**COUNCIL SUBMISSION - NOTICE OF EXHIBITION FOR THE PLANNING PROPOSAL AT
241-245 PENNANT HILLS ROAD, CARLINGFORD**

Planning Proposal 241-245 Pennant Hills Road, Carlingford

**Council Submission
20 June 2022**

Attachment 1 – Council Officer’s Alternative Scheme

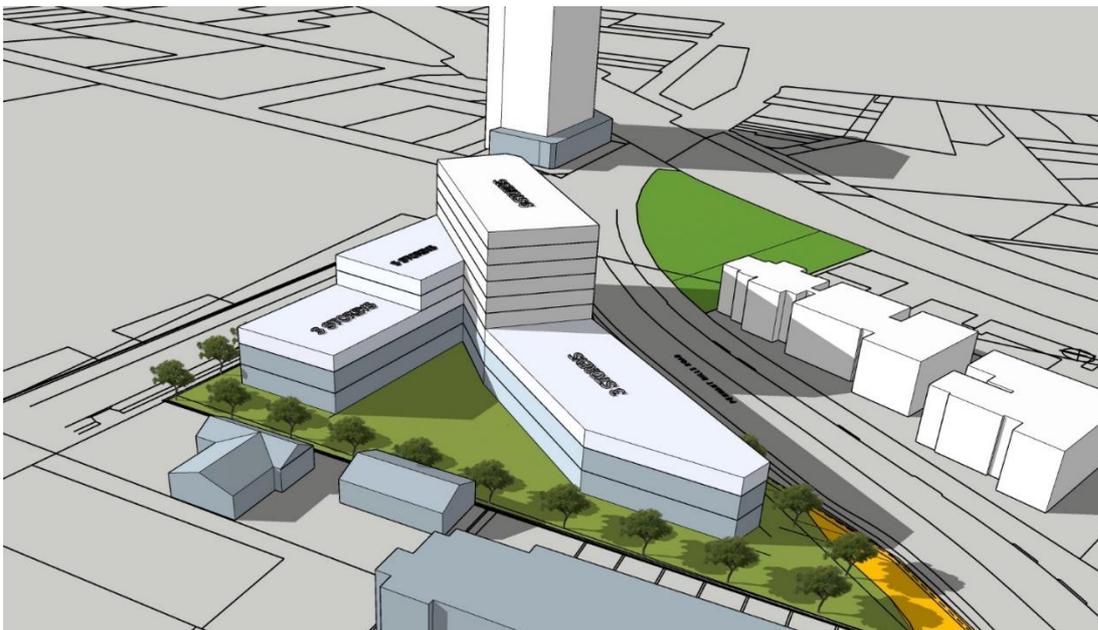
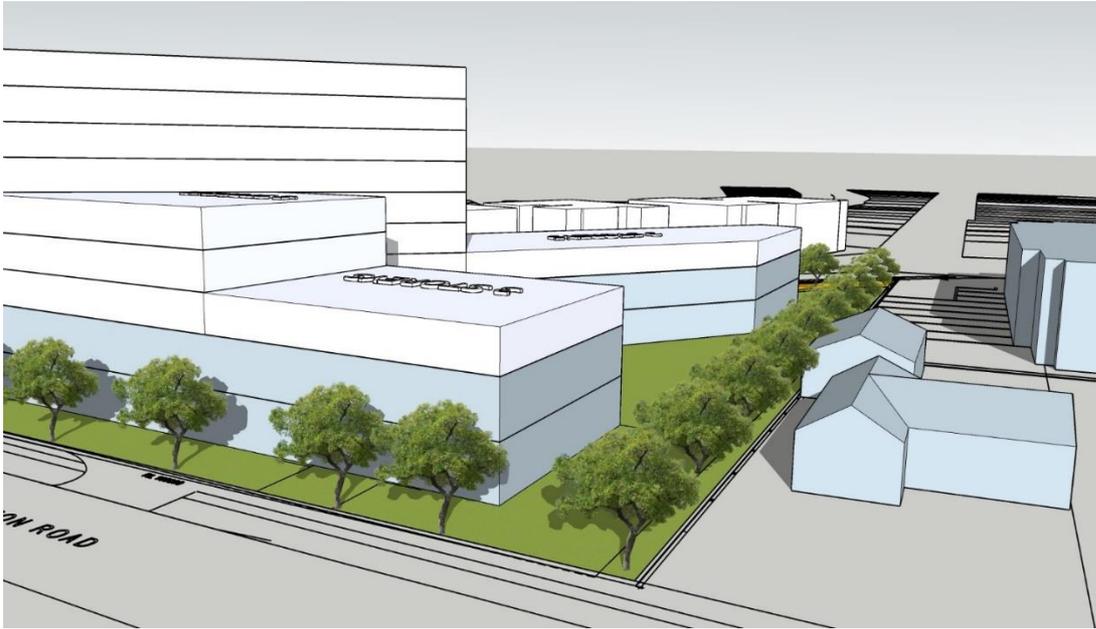
An alternative scheme has been developed that is consistent with the 1.5:1 FSR and 28m height limit that Council indicated could be supported on the site at its meeting of 22 July 2019. This scheme proposes a 1.5:1 FSR and maximum height of 27.9m that attempts to resolve the issues raised in the submission whilst also enabling a reasonable redevelopment to occur on the site.

The through-site link has been relocated against the western boundary. It will be 9m wide, which will allow for a deep soil zone and path access running north to south from Pennant Hills Road to Felton Road providing separation between the site and adjacent low density residential development.

- Road setbacks are 6m wide.
- Commercial space to ground floor of podium.
- Built form is distributed over 3 different heights:
 - Towers sit at 9 storeys along Pennant Hills Road down to a podium of 3 storeys closer to the western edge.
 - A secondary tower sits at 5 storeys to Felton Road and steps down to a 3-storey podium.
- The taller tower sits at the corner of the site.
- Communal open space to align in between the arc of the podium and connect to the through-site link on the west.
